P24-09
Event Center and Parking Lot

Property Owner: Legacy Hotel of Medina LLC
 Applicant: Ian Jones
 Location: 253/257 South Court Street and 226 South Elmwood Avenue
 Zoning: C-2 (Central Business)
 Request: Conditional Zoning Certificate and Site Plan approval for the construction of an event center and parking lot

COMMUNITY DEVELOPMENT DEPARTMENT STAFF RECOMMENDATION

PRELIMINARY SITE PLAN

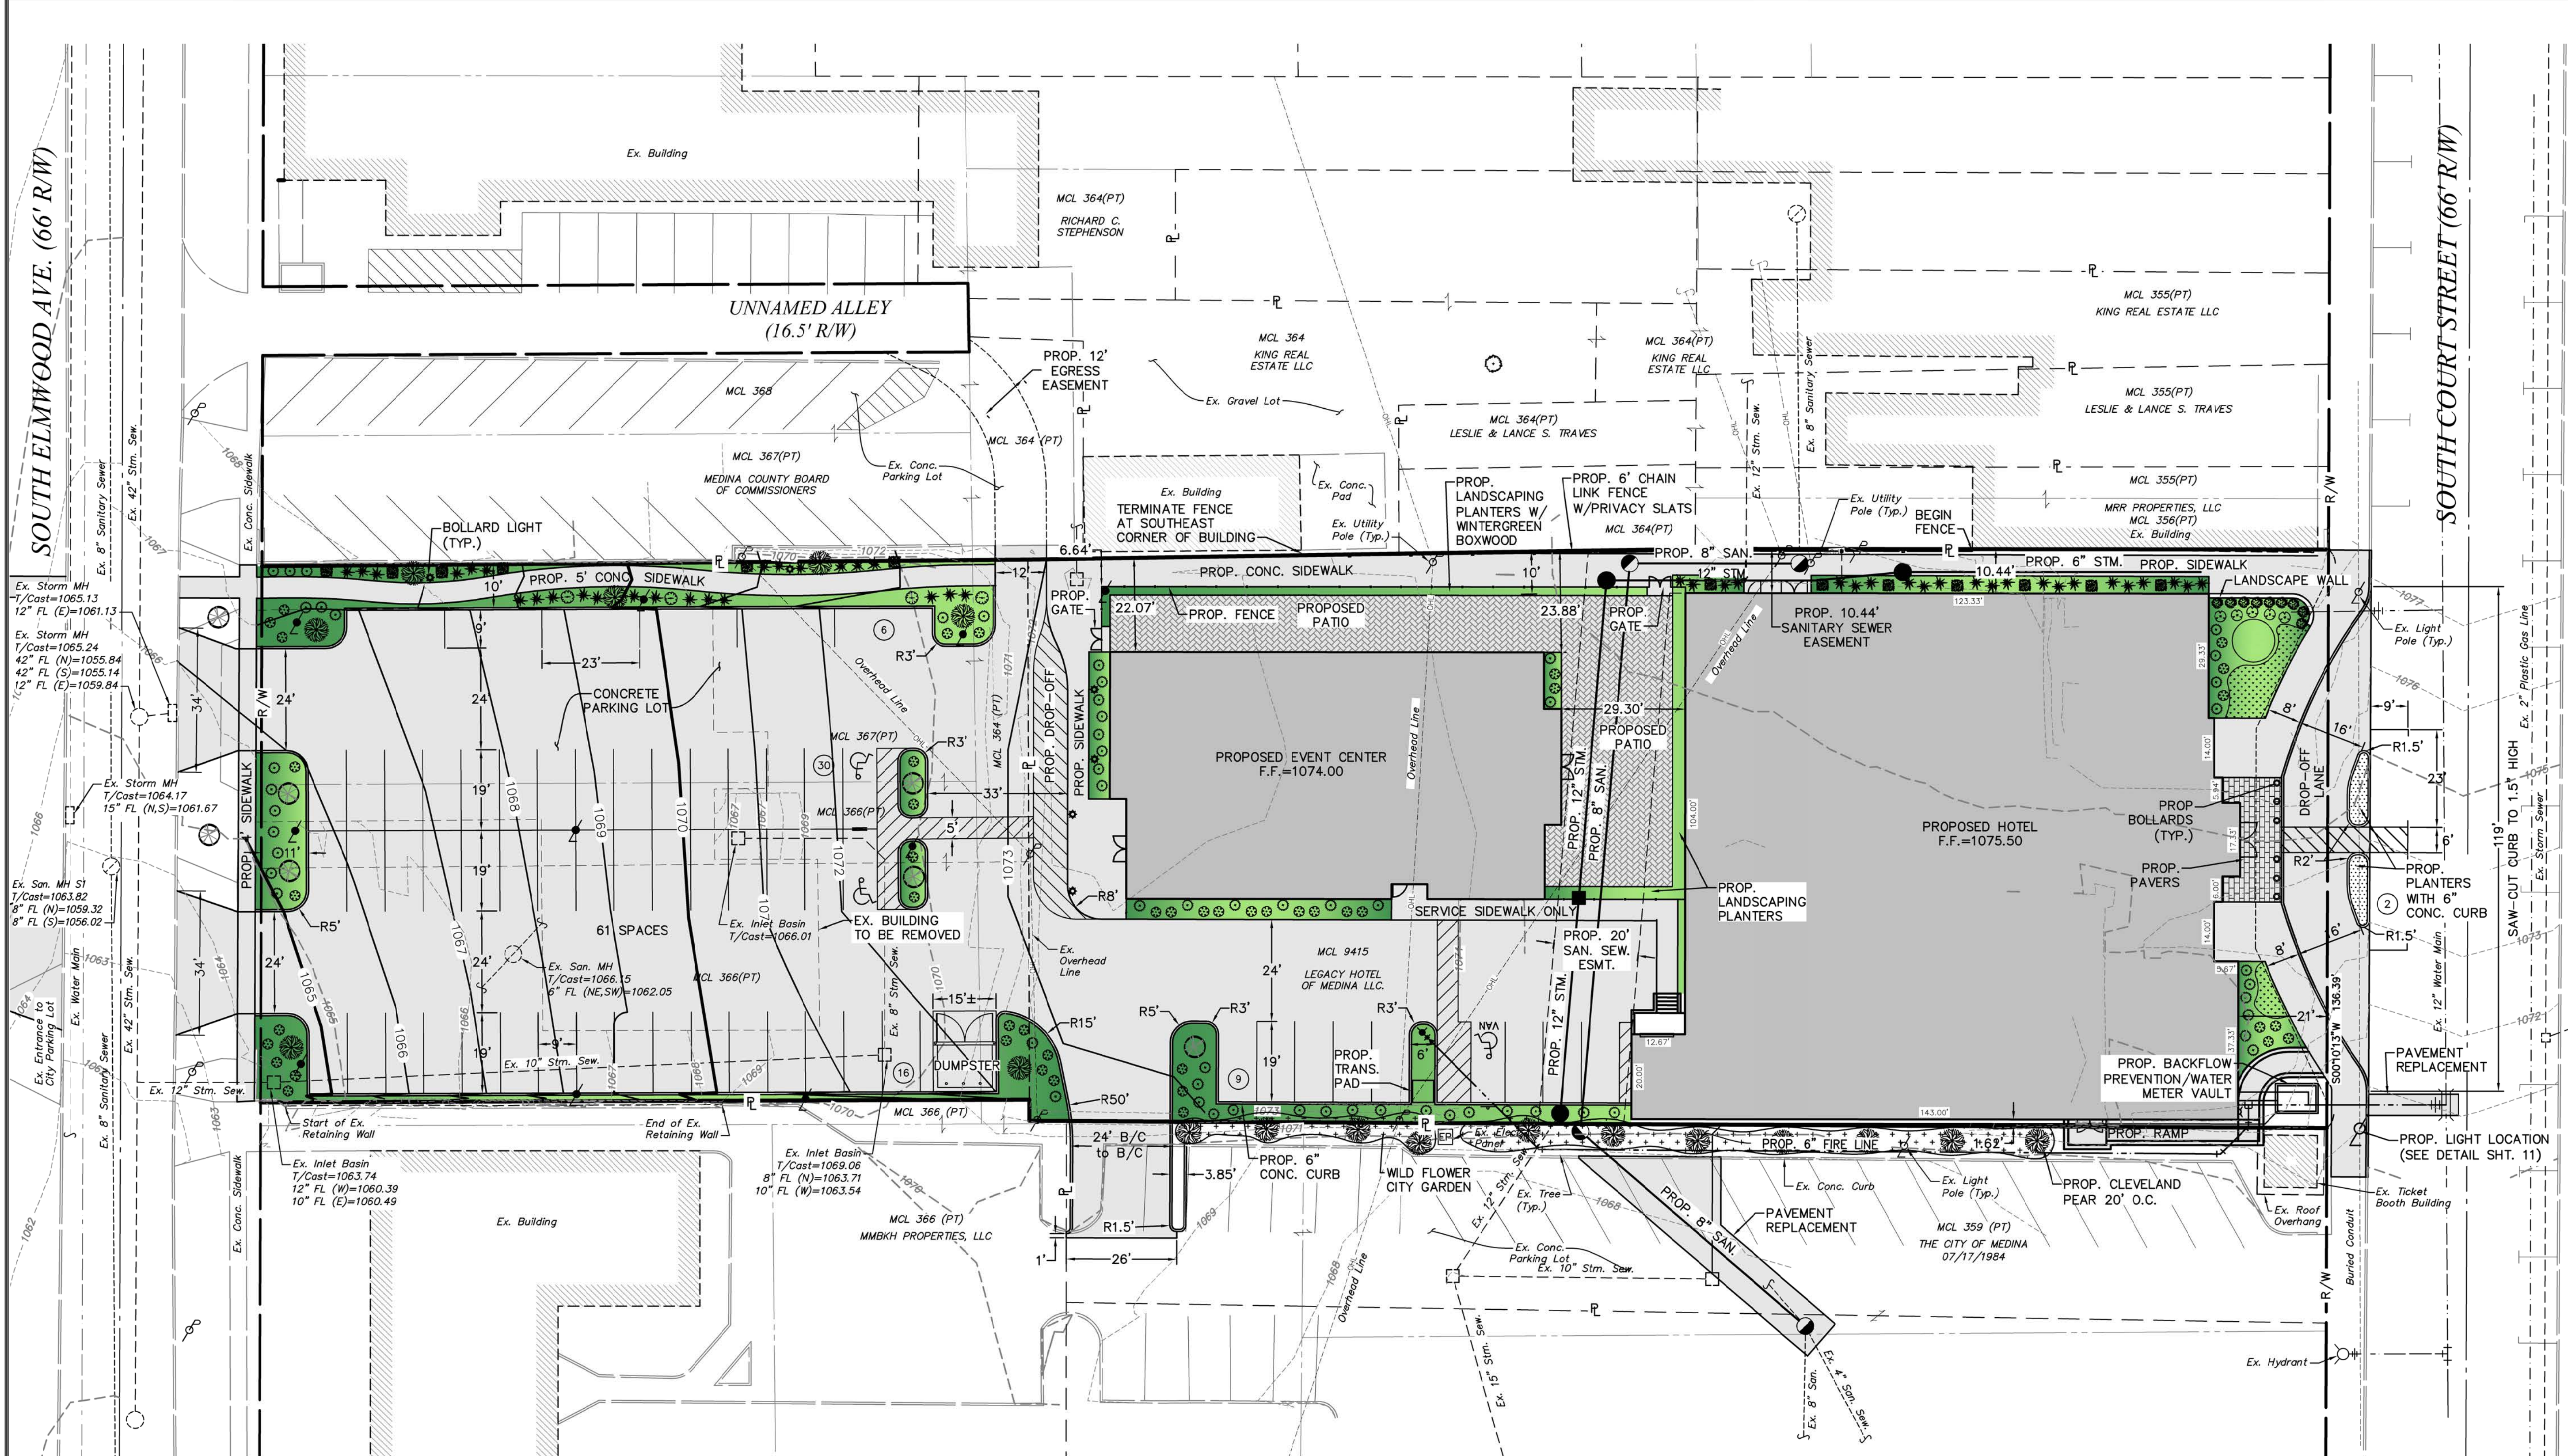
- The location of the fire hydrant must be moved to the west side of the south entrance.
- The dumpster should be moved to the west of the location currently shown so as not to further impede access to the east. (Revised plans relocate the dumpster to the west as requested)
- Install a man gate in the north chain link privacy fence, in the area of the proposed patio. This man gate should have panic hardware to allow for emergency egress through the fence to the north. The gate may, at the owner's discretion, be marked for "Emergency Exit Only", and is not required to have entry hardware on the north side.

1. Please refer to the attached engineering checklist for site plan approval.
2. The relocated public sanitary sewer will cross under a portion of the parking lot and the finished patio between the two buildings. The easement that will be granted to the City shall include language that if any maintenance or repair of the sewer that requires excavation in order to expose the sewer, once completed, while the excavation will be backfilled to grade level, however, the City nor the County Sanitary Engineers will not be responsible for restoring either the parking lot or the patio to their previous condition. In addition, the easement will absolve the City and the County of any liability for damage cause to either adjacent structure as a result of the work to maintain and/or repair the sewer.

3. As noted on the attached checklist, a storm water management analysis will be required. Please be aware that because the disturbed area of the revised project now exceeds 1 acre, the EPA will require that a storm water quality treatment system be included with the project. In addition, a storm water operations and management agreement between the property and the City will be required.

4. Regarding the proposed egress easement between the hotel property and the City's public right of way (unnamed alley), now that the revised site plan includes two access points to S. Elmwood Avenue directly from the hotel property, I wonder if a third access point is necessary. In addition, the City Law Director has determined that the easement is a private street and therefore must be constructed to the requirements of a public street. Lastly, as presented in the site plan, it is not clear how the flow of traffic between the one way egress from the hotel, the one way (east bound) traffic flow from the County parking lot, and the two way traffic flow from the public alley will be managed. I believe a more detailed traffic management plan/pavement marking plan should be developed for review. If the Commission does approve this access, I would ask that it is approved conditionally until that plan can be reviewed.

1. The location of the fire hydrant must be moved to the West side of the South entrance.
2. The Dumpster should be moved to the West of the location currently shown so as not to further impede access to the East.
3. Install a man gate in the North chain link privacy fence, in the area of the proposed patio. This man gate should have panic hardware to allow for emergency egress through the fence to the North. The gate may, at the owner's discretion, be marked for "Emergency Exit Only", and is not required to have entry hardware on the North side.

2. Plans shall incorporate changes requested by the Fire Department including the relocation of a fire hydrant to the west and the installation of an emergency egress gate in the fence along the north property line.

3. An update of the previously submitted Parking Supply and Demand Analysis, a storm water management plan, and a stormwater operations and management agreement shall be submitted and approved by the City Engineer.

4. The access point to the north shall be eliminated or the drive within the "Proposed 12' Egress Easement" shall be improved and a traffic management/pavement parking plan shall be submitted as required by the City Engineer.

PHOTOMETRIC SITE PLAN
 LEGACY OF MEDINA HOTEL
 257 S COURT ST.
 MEDINA, OH 44256

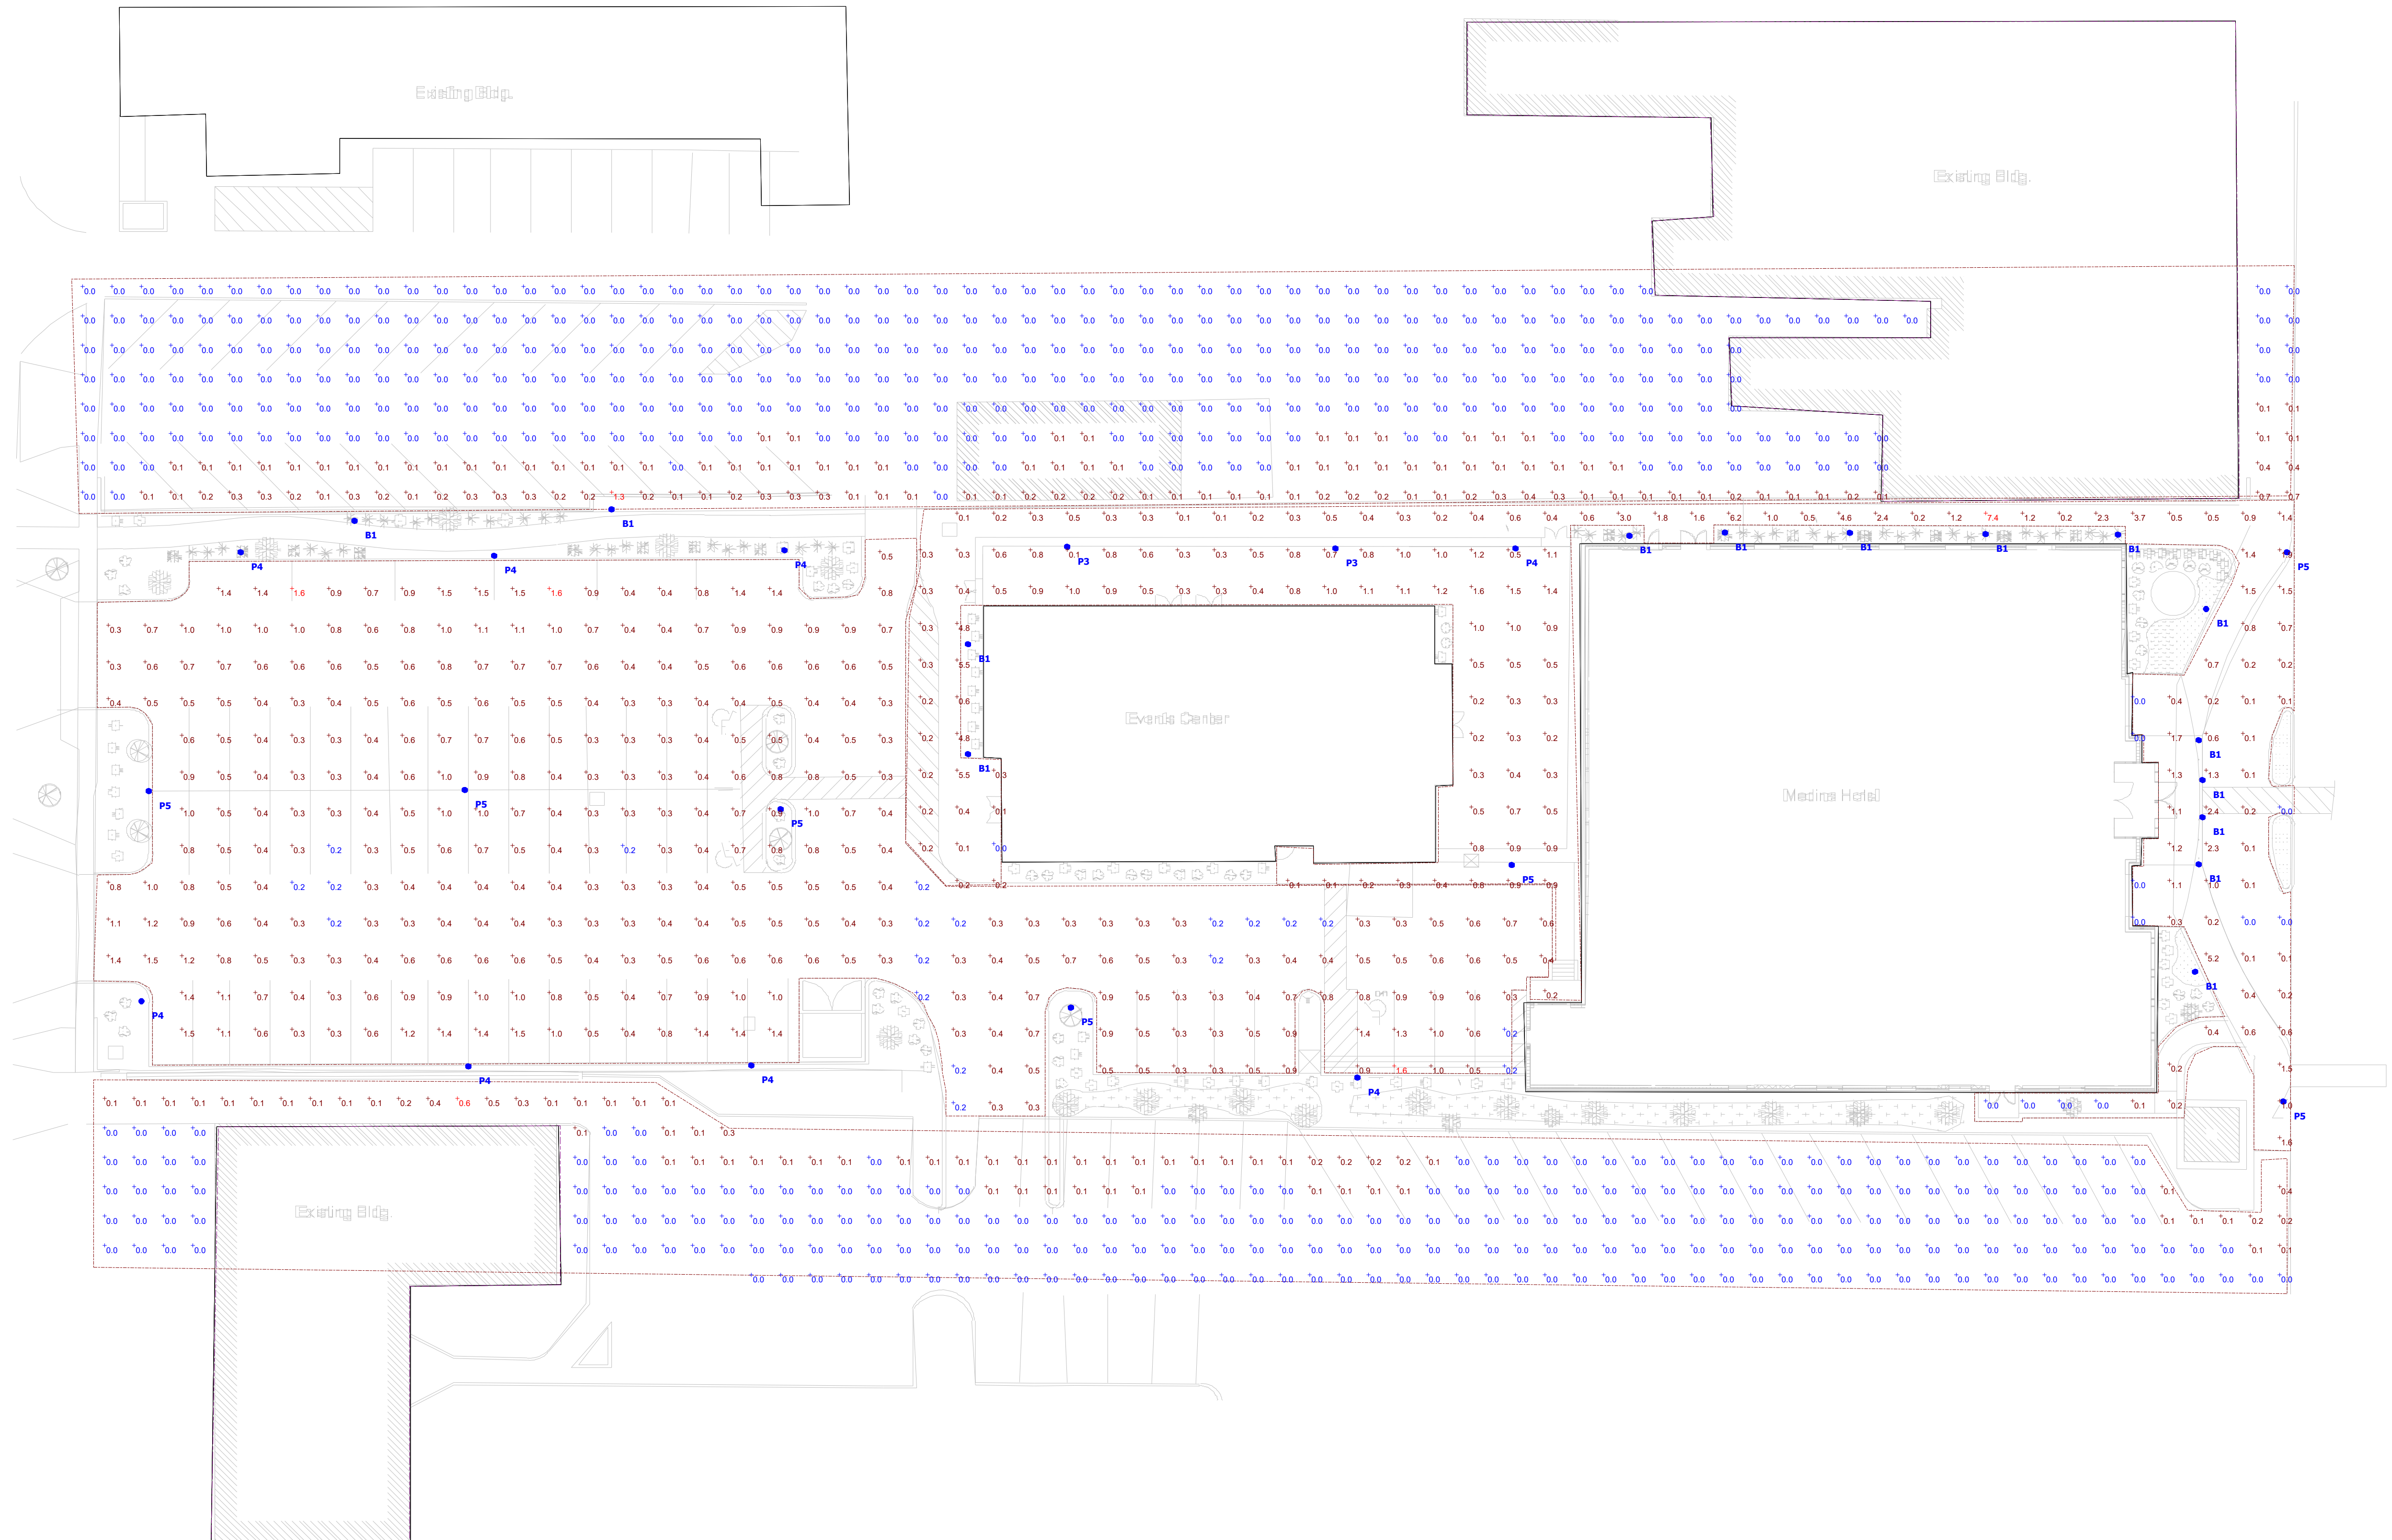
A lighting plan will have been submitted in compliance with Section 1145.09(c) including a photometric plan and full cut-off fixtures. Parking lot lights are limited to 10 ft. in height, unless a taller height is authorized by Planning Commission. The applicant has requested a parking lot light height of 15 ft., which is lower than commonly found in commercial areas.

5. Parking lot lights are permitted at a height of 15 ft.
6. The project shall comply with Planning and Zoning Code Sections 1135.06 regarding building footprint and 1145.10(c) regarding parking setbacks on an entry drive or a variance shall be approved by the Board of Zoning Appeals.
